WRAPPER CLUTCH KIT (1:1 RATIO)

UPGRADE FOR:
Model 296 Continuum Traypacker

General Description:

Figure 1.3 - Original Wrapper Clutch

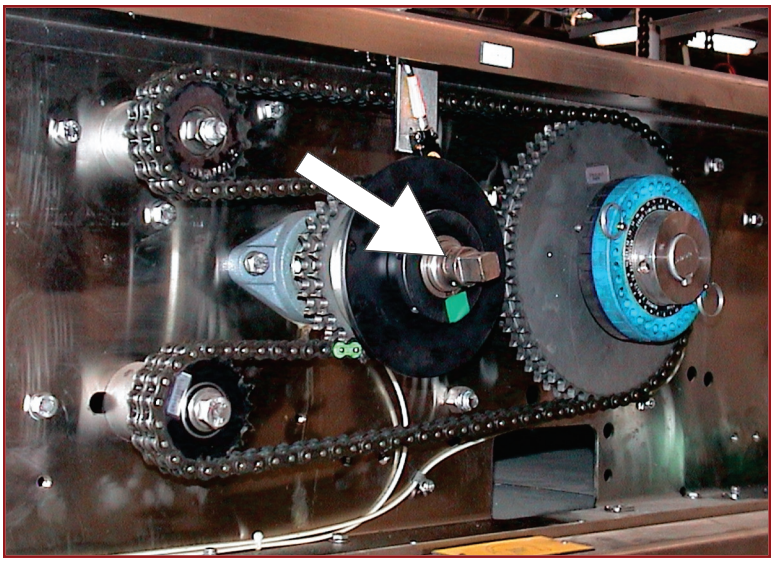
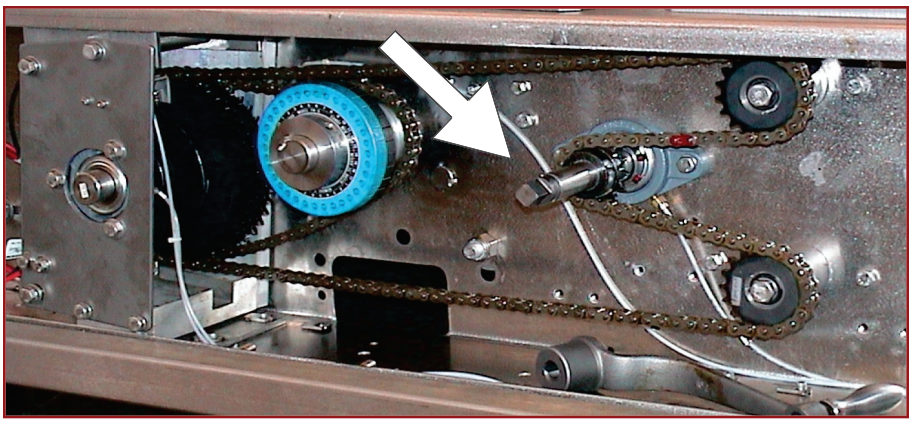
Currently, when the wrapper clutch trips due to a jam in the flight bar area, an operator must rotate the clutch approximately 56 times to reset the clutch into its exact position. Many operators will quickily try to reset the clutch to a position that is close to the correct position but not exact. To compensate for the difference, operators will pull the pins on the phaser and reposition.

Installation of a new clutch with a 1:1 ratio in the wrapper section of a 296I or 296P Continuum.
(Removal of original wrapper clutch is required.)

When resetting the wrapper clutch, this kit provides a quick and positive recovery procedure and eliminates the need to adjust the flight bar phaser
